Contract #: 04-0120F4
 Cty: SF/ALA Rte: 80 PM: 13.2/13.9
 File #: 69.25B

QUALITY ASSURANCE -- NON-CONFORMANCE REPORT

Report No: NCR-000222

Reference Description: Nonconforming class A indications on welds SEG-019-027 and SEG-019-028

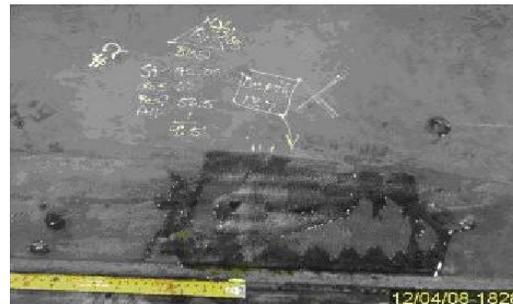
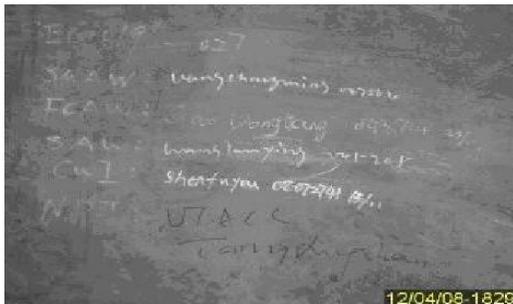
The contractors Quality Control (QC) Ultrasonic Testing (UT) technicians have accepted nonconforming class A indications on welds SEG-019-027 and SEG-019-028. See attached photos.

AWS D1.5 2002 Table 6.3, "Class A (large flaws) Any indication in this category shall be rejected (regardless of length)."

The response is acceptable, but the Non-Conformance is not closed.

Please provide the above mentioned training documentation. Also, please provide documentation of the weld repairs that were performed and that the repairs were acceptable.

The proposed resolution is acceptable. Training regarding Ultrasonic Testing (UT) application was performed, and the welds in question have been accepted by UT as shown in the attached documents. The Department concurs that Non-Conformance ZPMC-0198 is closed.

WELD NUMBER: SEG019*-028

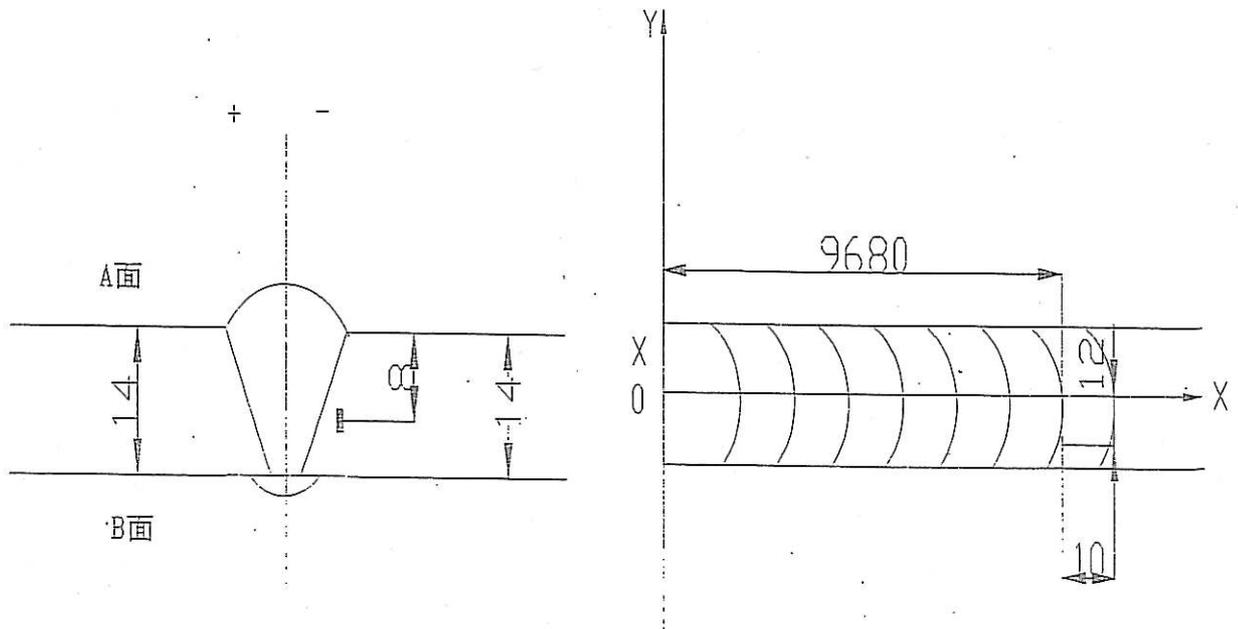
Rejected indication found by ultrasonic inspection is less than the maximum allowance aggregate length.

1. 焊道未及时处理干净。
1. Did not clear the weld pass completely in time.

1. 从B面采用碳刨或打磨的方法去除焊缝缺陷;
 2. 参照返修焊接工艺规程 (WPS) 准备正确的接头型式, 预热和焊接;
 3. 焊前对修补区域进行VT与MT检测保证缺陷完全被清除;
 4. 将修补区域打磨到与母材或邻近焊缝平齐;
 5. 根据批准的车间图纸检查焊缝.
-
1. Gouge or grind from face B to remove all defects;
 2. Follow repair WPS for joint preparation, preheat, and weld deposit;
 3. Verify with VT and MT no defects remain in the weld joint prior to welding;
 4. Grind the repaired area flush with base metal or the adjacent weld;
 5. Check the welds according to the working drawings.

WELD NUMBER: SEG019*-027

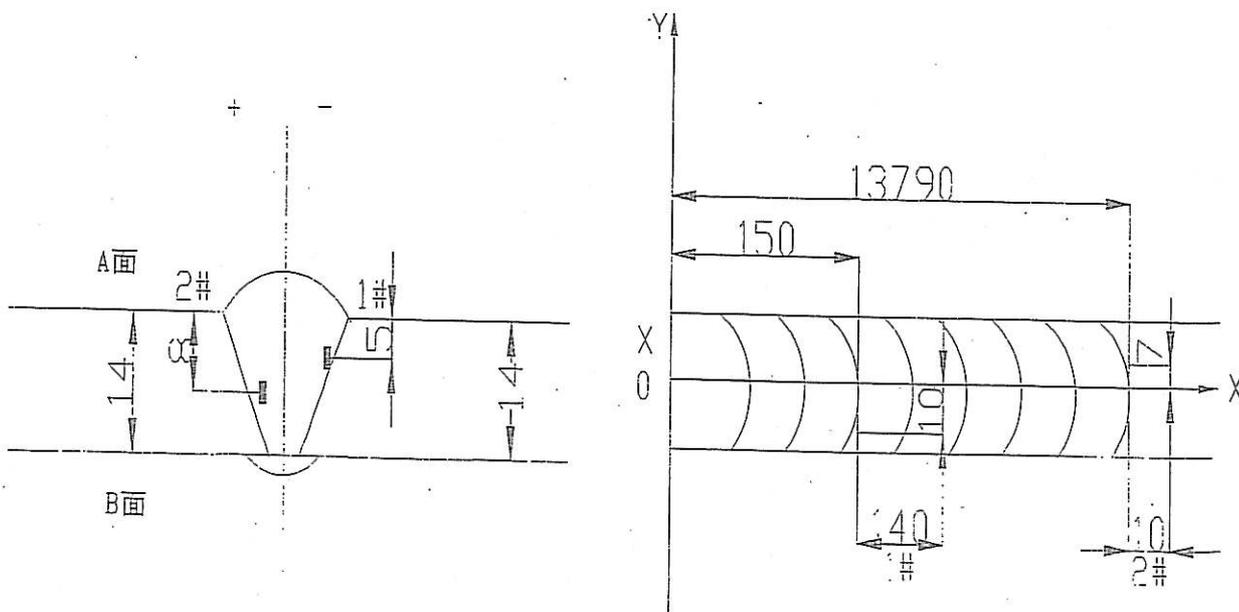
Rejected indication found by ultrasonic inspection is less than the maximum allowance aggregate length.

1. Did not clear the weld pass completely in time.

1. Gouge or grind from nearer side from metal edge ($D \leq 1/2T$, "D" is depth of defects, "T" is thickness of metal) to remove all defects;
2. Follow repair WPS for joint preparation, preheat, and weld deposit;
3. Verify with VT/MT no defects remain in the weld joint prior to welding;
4. Grind the repaired area flush with base metal or the adjacent weld;
5. Check the welds according to the working drawings.
